**HUON VALLEY  
COUNCIL**

# **Summary of Community Engagement**

## **Franklin Master Plan Stage 3 Sporting Precinct**

**REVISED PLAN  
FOLLOWING  
CONSULTATION**

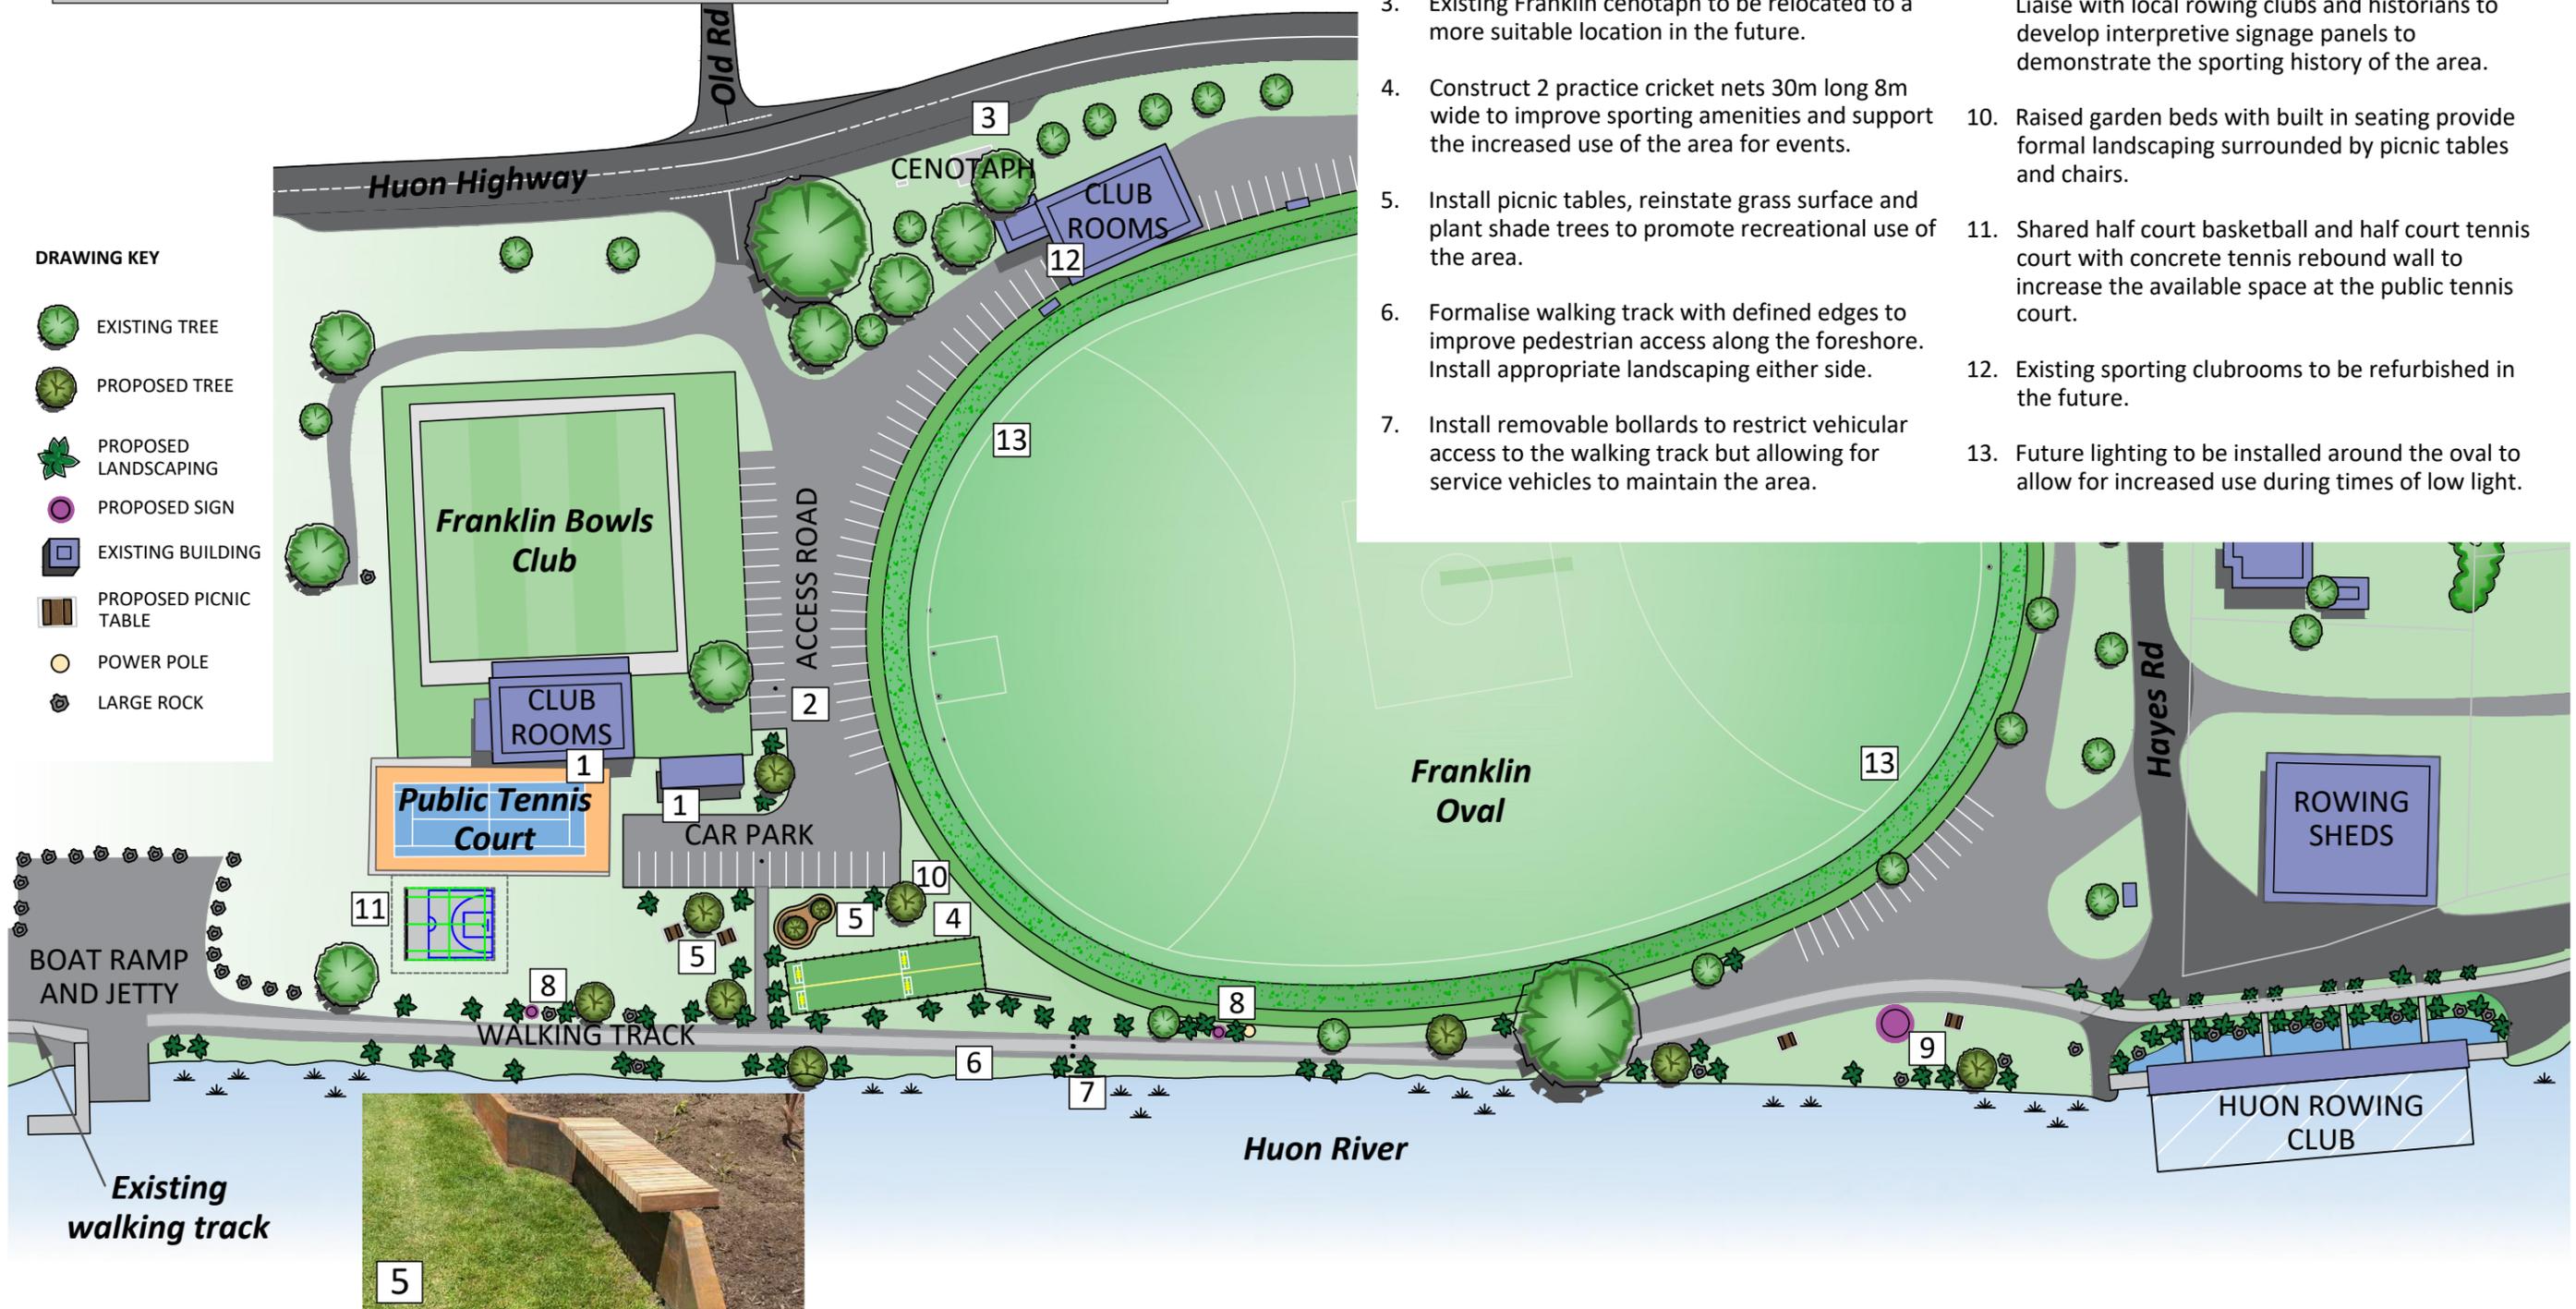
Based on the feedback and suggestions received, amendments have been made to the Draft Master Plan as follows:

- a) Gravel walking track (6)
- b) Removable bollards to replace gateway (7)
- c) Raised garden bed with landscaping, picnic tables and seating to replace handball court (11)
- d) Handball court be included in multi-use court with tennis rebound wall and basketball hoop (12)
